## Adequacy Review No. 2, Bill Nelson Borrow Pit, M2023-010

*RE: IHC Scott, Inc. – W. Max (Bill Nelson) Borrow Pit, File No. M-2023-010, New 111 Construction Materials Application Adequacy Review Letter No. 2 Response*

# SLOPE STABILITY REPORT

FOR THE  
W. MAX (BILL NELSON) BORROW PIT  
WASHINGTON COUNTY, COLORADO

### Slope Stability Case Location Map

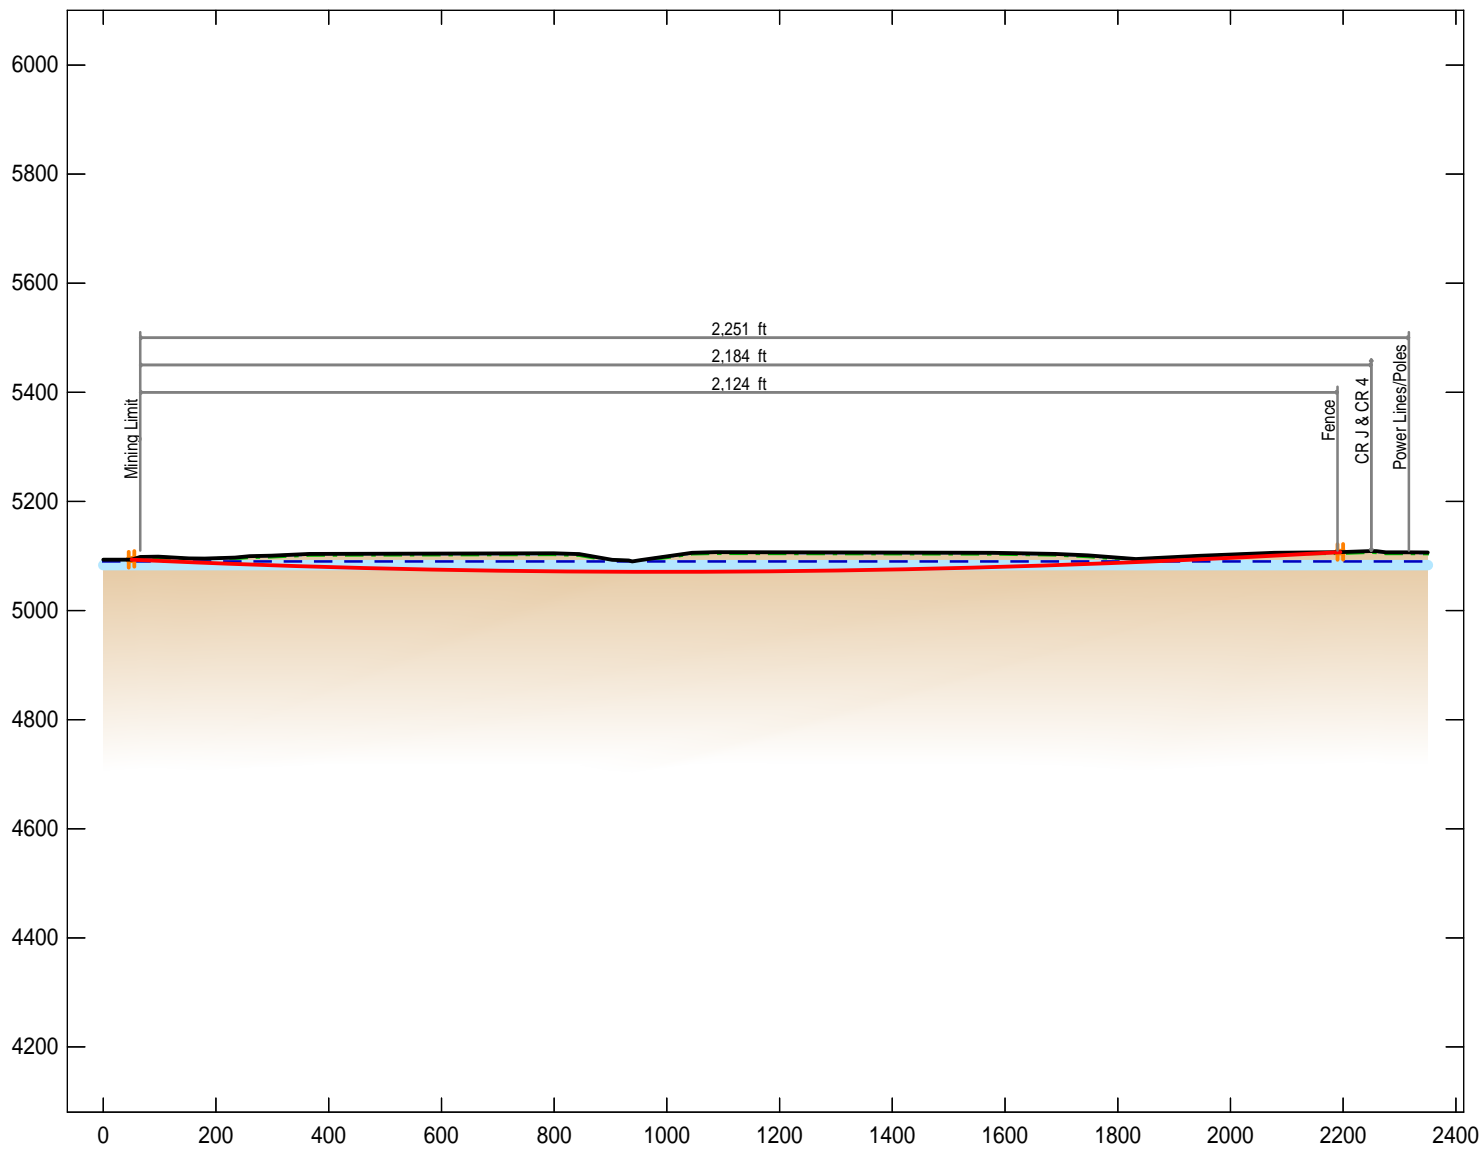
1. The Division reviewed the updated maps and there are three permanent man-made structures, which the Operator needs to obtain structure agreements for, within 200 feet of the affected land boundary. Those structures are County Road CR4/CRJ, the fence between the Nelson/Schueller properties and the Mountain View Electric Association powerline and poles. Pursuant to Rule 6.3.12, where the mining operation will adversely affect the stability of any significant, valuable and permanent man-made structures, located within 200 feet of the affected land, the applicant may either:

The location of the case is shown on the case location map included in Appendix A.

### **Case SS-1 – Fence, County Roads J & 4, Power Lines & Poles East of Pit.**

The mining operation is adjacent to a fence, County Roads J & 4, and power lines and poles on the east side of the pit. The proposed setbacks for mining are 2,124 feet from the fence, 2,184 feet from County Roads J & 4, and 2,251 feet from the power lines and poles. The mining depth was assumed to be 5 feet.

***Response: A slope stability evaluation is attached that demonstrates the no damage to the adjacent structures will occur as a result of the mining activities.***

**Case SS-1** – At setbacks of 2,124 feet from the fence, 2,184 feet from County Roads J & 4, and 2,251 feet from the power lines and poles, the lowest resulting static condition safety factor of 236.84 exceeds the MLRB minimum requirement of 1.50 for an embankment adjacent to a critical structure. The lowest resulting pseudo-static condition safety factor of 12.05 exceeds the MLRB minimum requirement of 1.30 for an embankment adjacent to a critical structure subject to earthquake loading. The proposed setbacks are satisfactory.
